**CITY OF ALBUQUERQUE  
PLANNING DEPARTMENT**

**DRB Comments**

**PROJECT # 1003797**

**RE: Lot 13, Block 57, Terrace Addition/sketch**

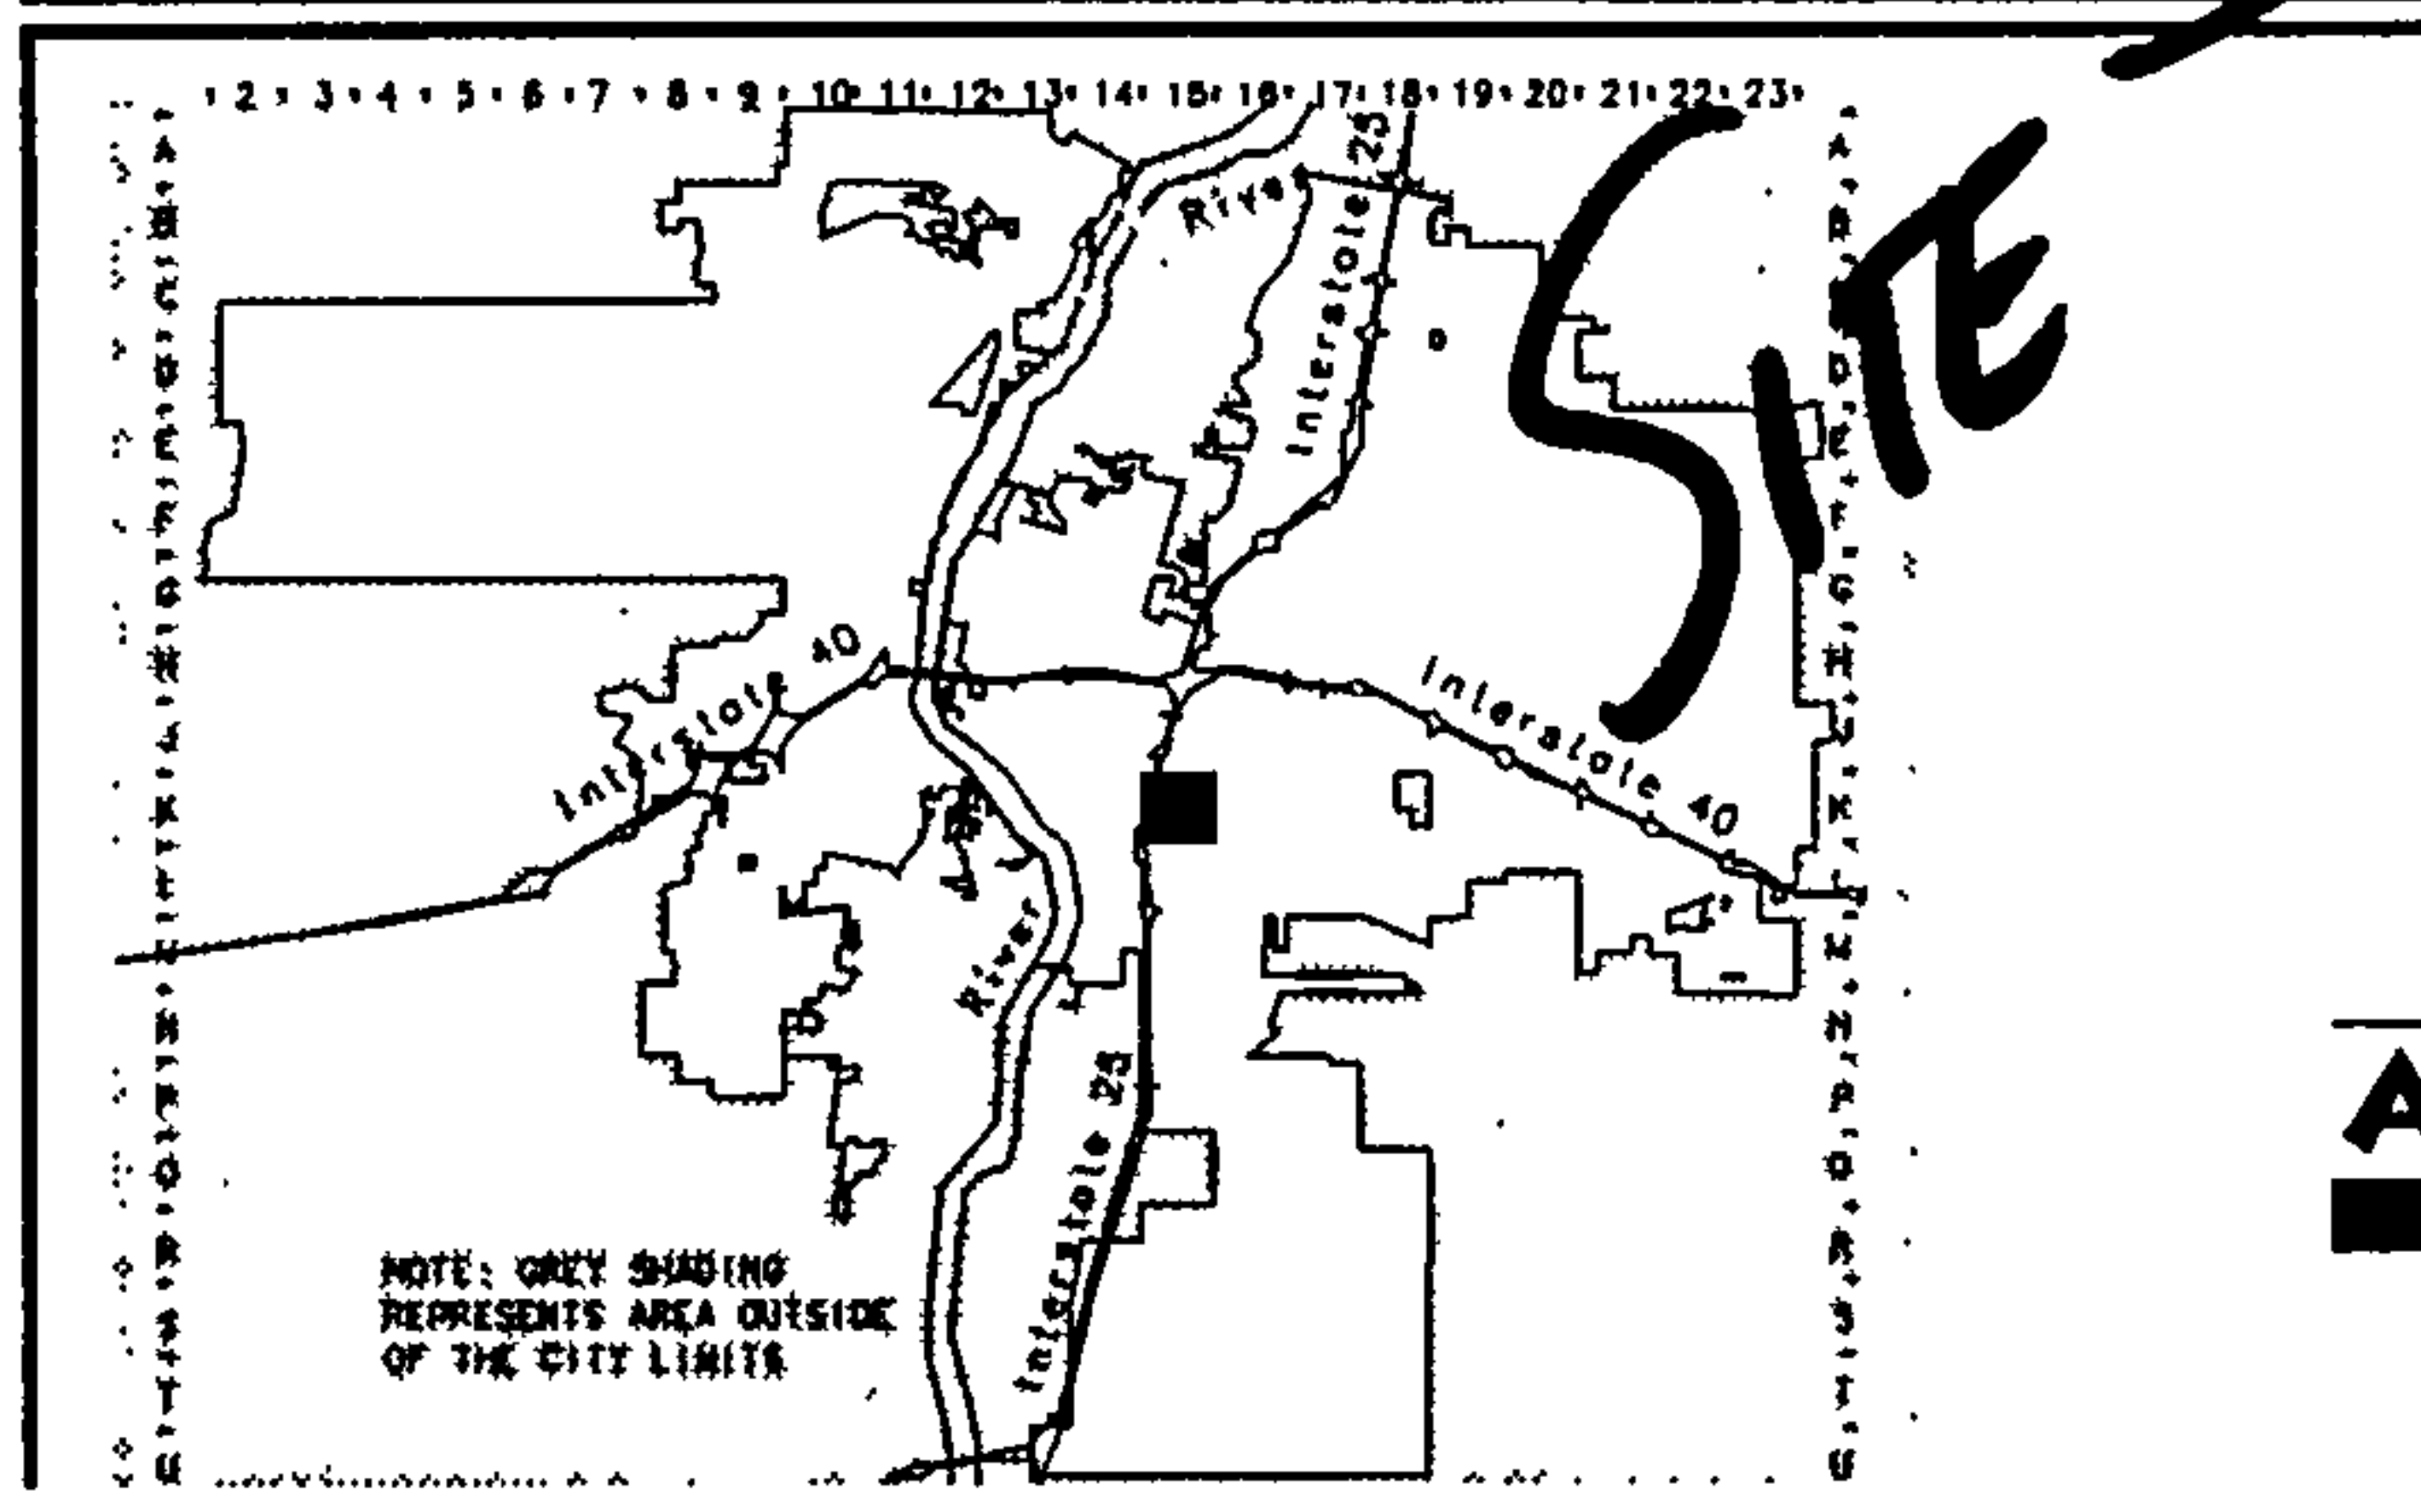
The Sector Plan on page 70 under the DR Diverse Residential states the minimum lot size in this zone is 6,000 square feet. Section 14-16-2-11(D)(1) of the Zone Code under R2 zoning to which the Sector Plan refers also requires a minimum lot size of 6,000 square feet. Neither of the 2 lots shown on the sketch plat meet this requirement.
